FINAL PLAT OF
"DEER CREEK ESTATES
SECOND ADDITION"

S/D 98-21 - Final Plat of VANDERHOFF ESTATES

At the regular meeting of the Subdivision Committee of the Metropolitan Area Planning Commission on Thursday, August 20, 1998, the above captioned plat was considered. The action of the Committee was to approve the final plat, subject to the following:

CASE NUMBER: S/D 98-21 - VANDERHOFF ESTATES

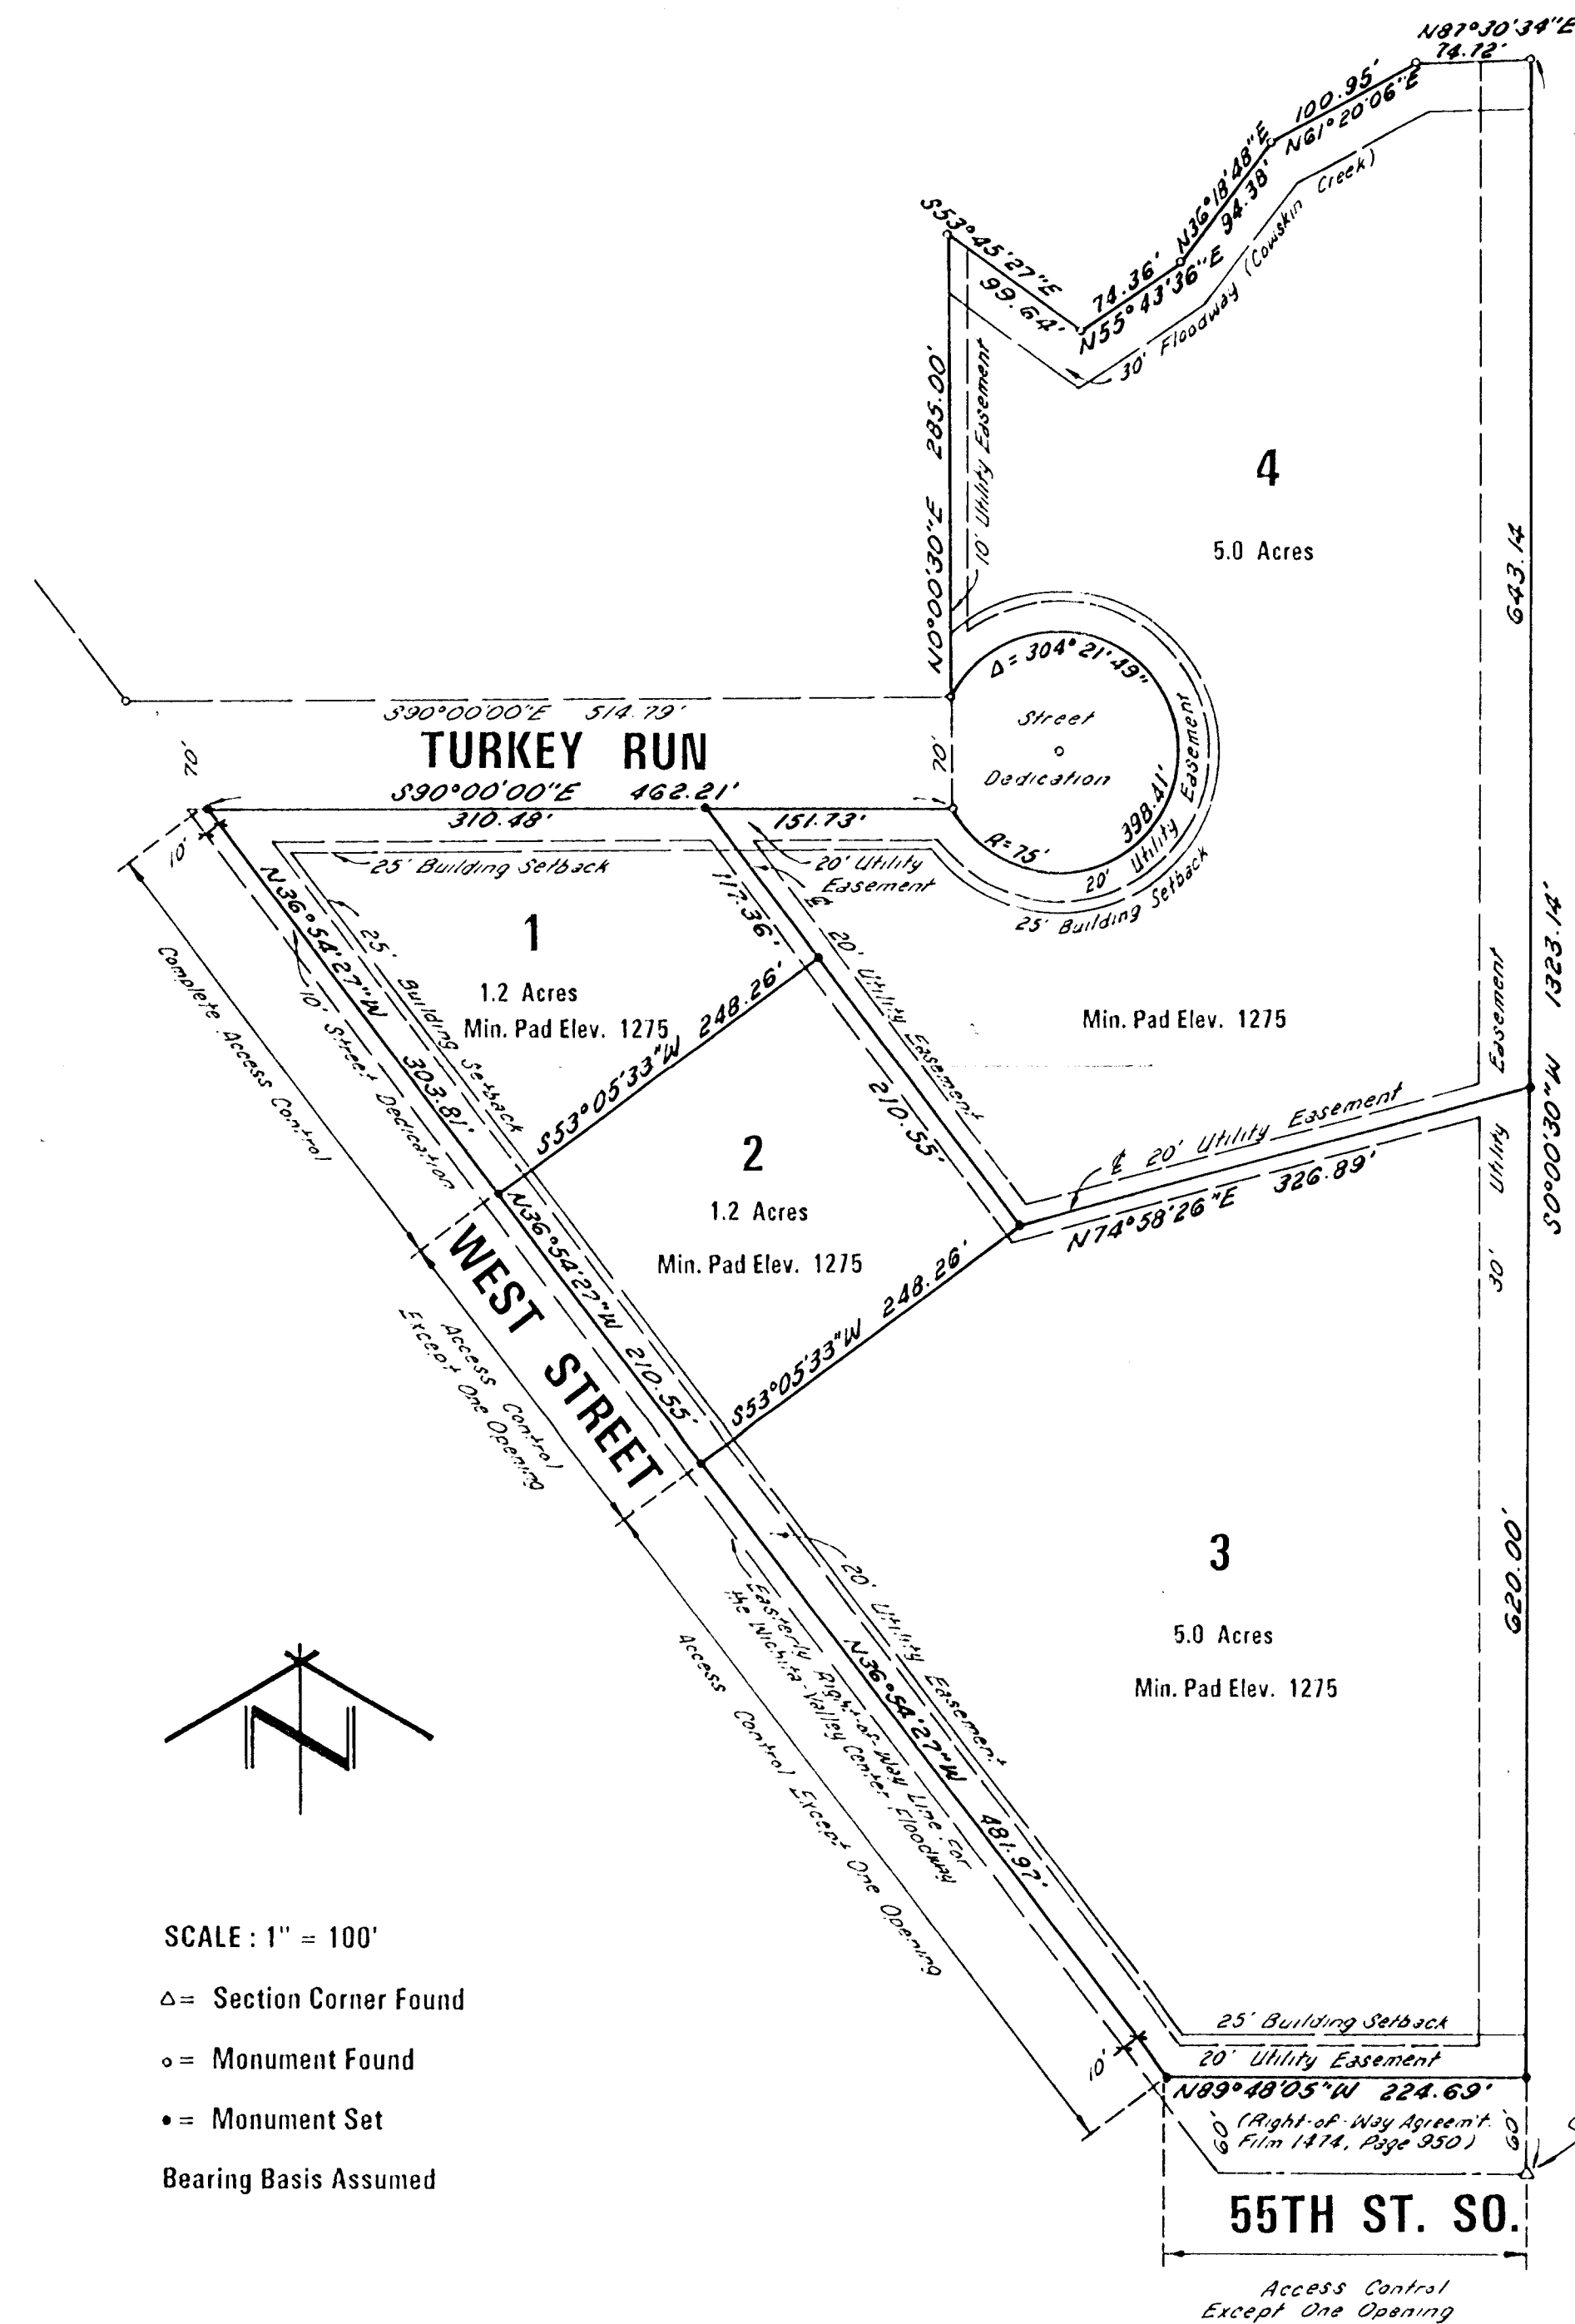
- C. City Engineering needs to indicate the status of Wichita water and sanitary sewer service for this area and what guarantees need to be provided at this time. *Guarantees will be required for future City water and sanitary sewer. An easement for future location of sanitary sewer needs to be denoted on plat.*

- E. County Engineering needs to comment on the status of the applicant's drainage plan. *The drainage plan has been approved.*
- F. County Engineering and MAPD recommends dedication of access control along West Street except for one opening each for lots 2 and 3. Access to Lot 1 shall be from Turkey Run. Subdivision Committee approves said openings in addition to an opening from Lot 3 to 55th Street South per applicant's desire to maintain an existing opening.

- H. It is recommended that the front yard utility easements are eliminated and replaced with rear yard utility easements. Overly wide utility easements (30 foot) are recommended to be platted in the rear of lots 3 and 4 to allow for the installation of utilities without damage to existing tree rows. *Subdivision Committee approved both front and rear yard easements to give developer an option of their location.*

The requested access controls have been denoted on the final plat.

The final plat denotes the requested 30-foot easement in the rear of lots 3 and 4.
